## Basement Impact Assessment (BIA) – Addendum 02

**Project:** Gloucester Lodge

**Job No:** 15060

**Date:** 04.10.2016

SUBJECT  
**Drainage Layout**

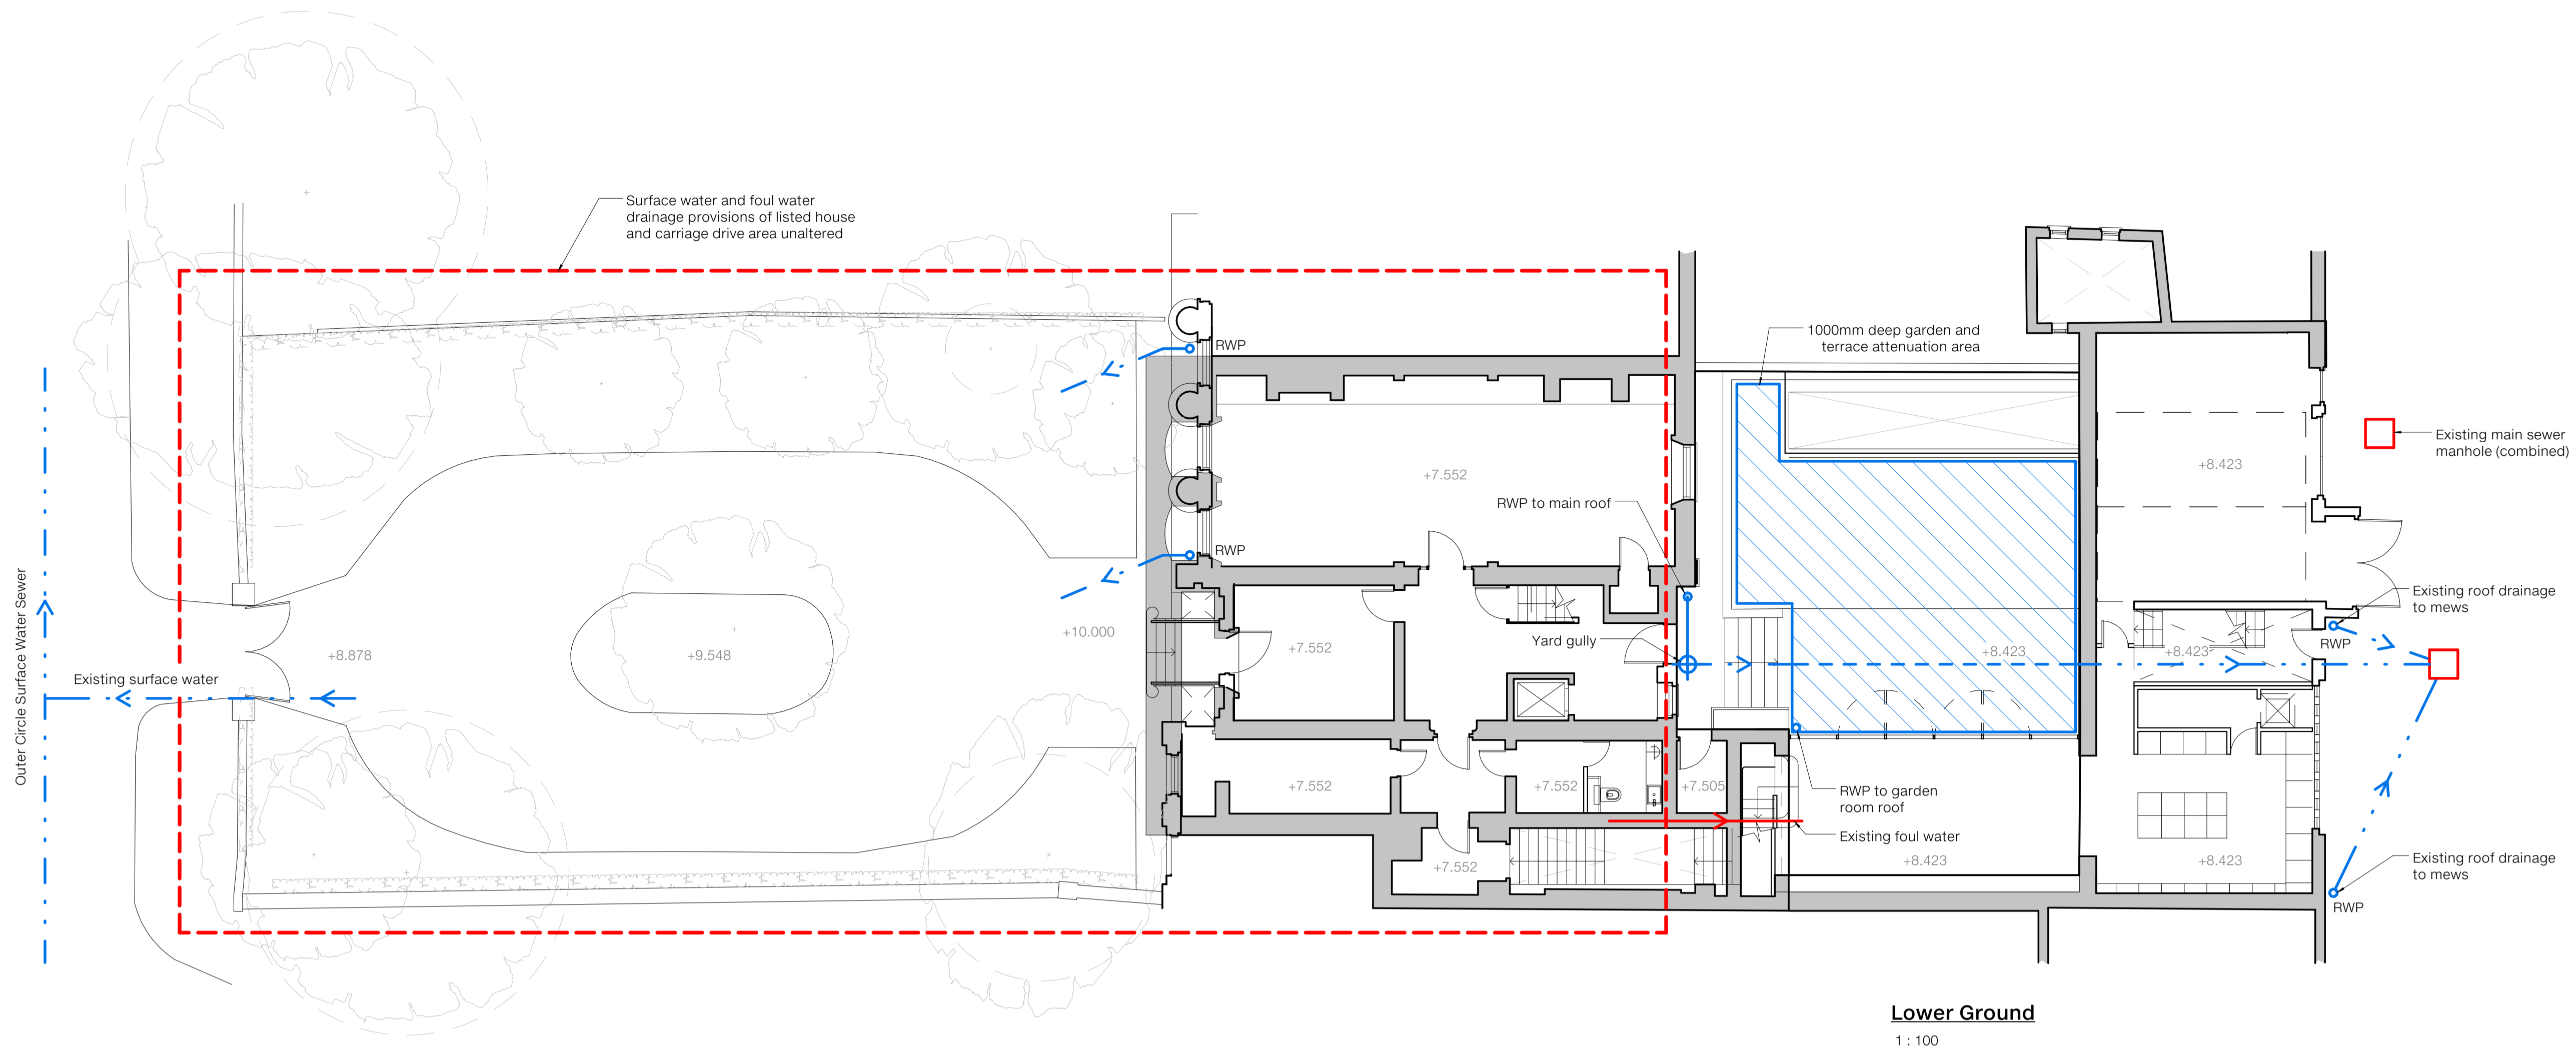
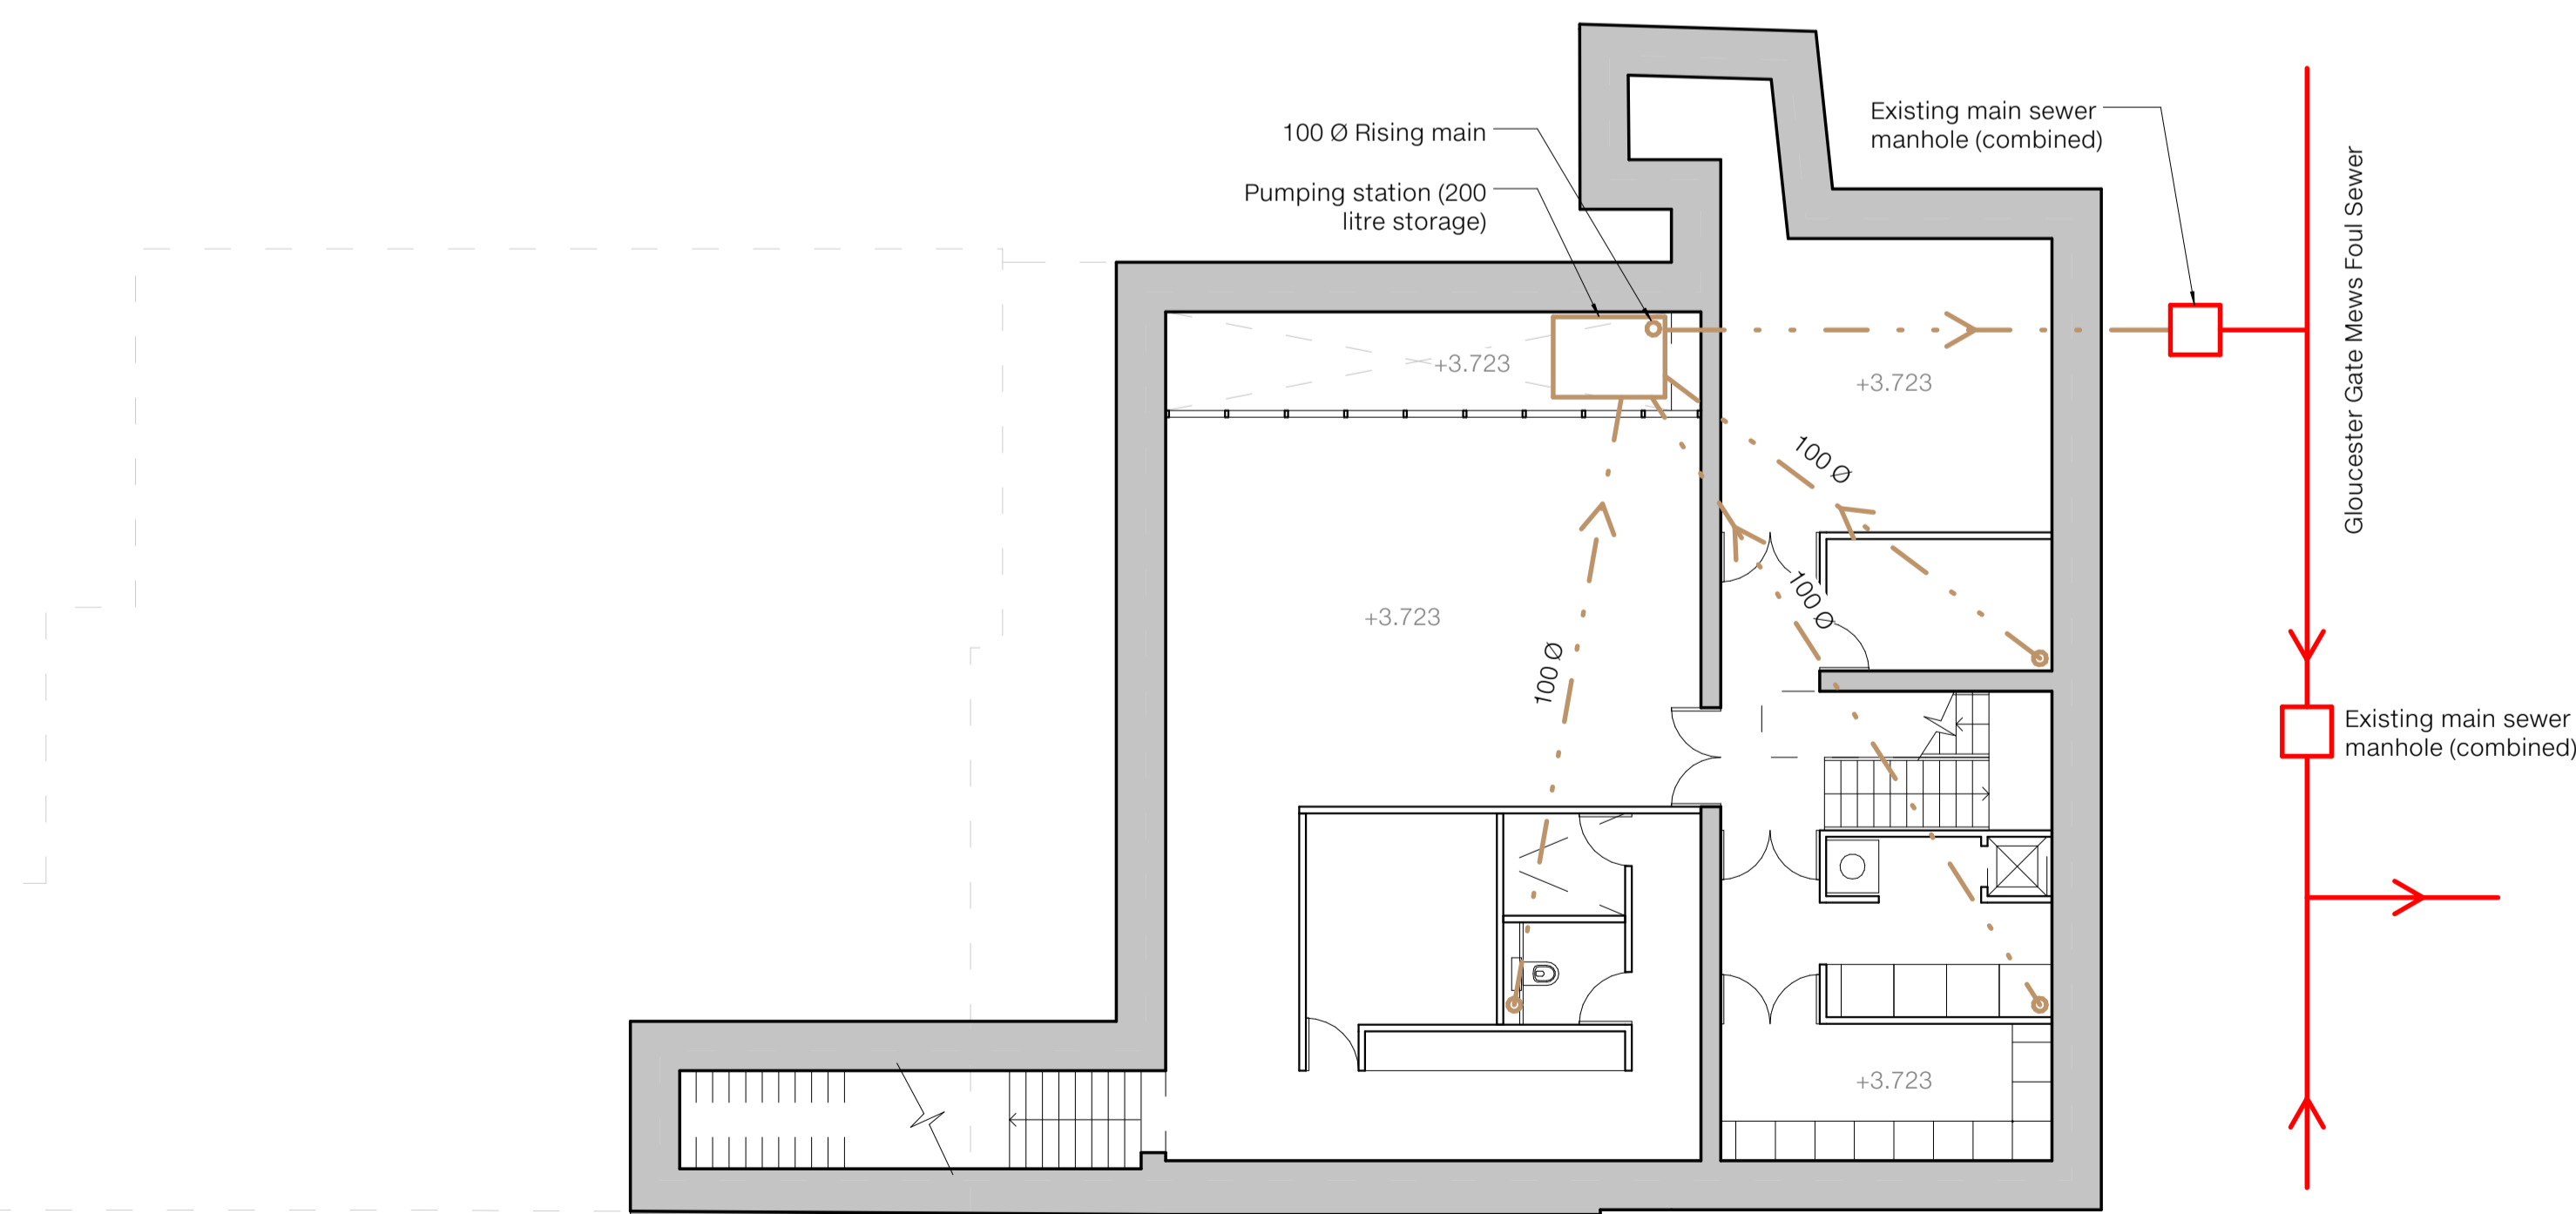
A preliminary drainage design has been prepared for this project. The site is in an area of low flood risk. Foul and surface water requirements are unaltered. There is a surface water sewer west of the site and a combined sewer in the mews to the east.

The main building and front garden are of historical significance. All drainage provisions in front of and within the main house remain unaltered. In the courtyard and mews area the foul drainage is relocated with the existing connection to the main sewer maintained.

Surface water run-off levels from part of the main house roof, the courtyard and the mews roofs are unaltered. The small area of planting along each side of the existing courtyard is replaced by an area of lawn 1 metre deep (8.423 AOD top level 7.4 AOD level on finishes above gym), This area together with a volume of attenuation beneath the proposed terrace area improves on the current discharge rates. SuDs provisions are limited by the site layout and ground conditions. Soakaways are not practical and additional attenuation can only be placed at levels already occupied by accommodation except in the front area which is not to be disturbed.

AREAS  
SUSCEPTIBLE  
TO MOVEMENT

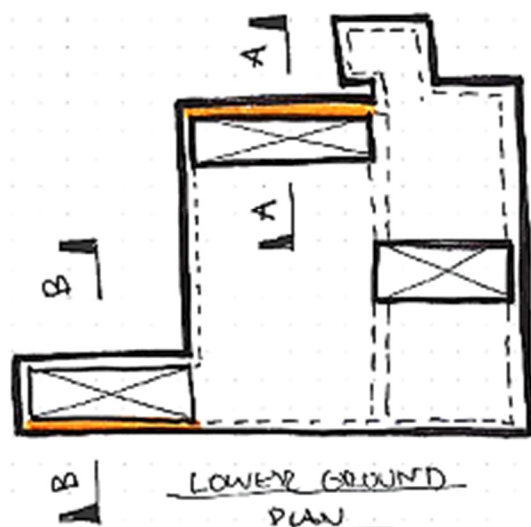
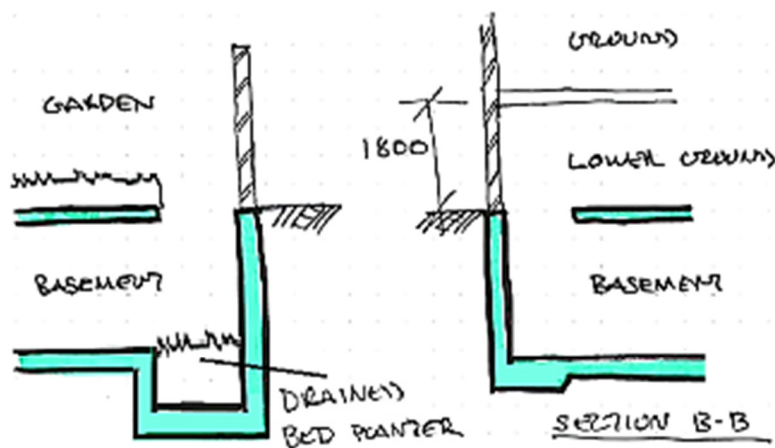
SECTION A-A

GARDEN WALL WILL  
MOVE WITH BASEMENT  
RC WALL. NO CRACKS  
OCCUR

SECTION B-B

MASONRY WALL ABOVE  
RESTRAINED BY GROUND  
FLOOR SLAB. POSSIBLE  
CRACK OCCURANCE. SEE  
NEXT PAGE FOR ASSESSMENT.

## Crack Width Calculation for the Maximum Movement

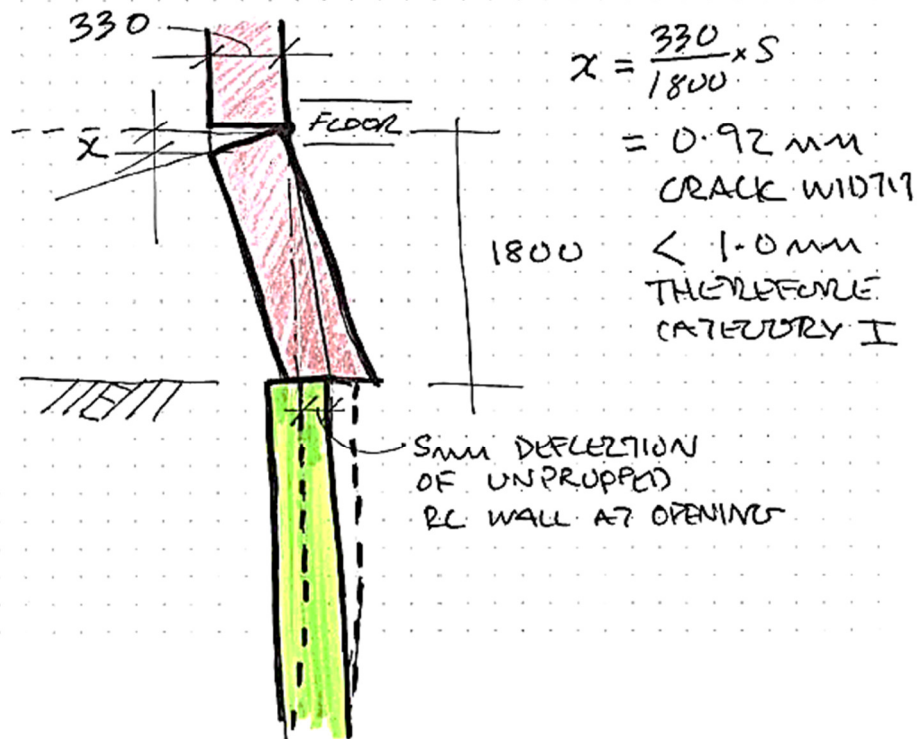
FROM THE FE ANALYSIS, THE RC WALL ADJACENT TO THE OPENING SHOWN IN SECTION B-B IN PREVIOUS PAGE IS EXPECTED TO MOVE LATERALLY BY 5MM. THE CORRESPONDING CRACK WIDTH INDUCED IN THE EXISTING WALL ABOVE IT, IS CALCULATED HEREIN.
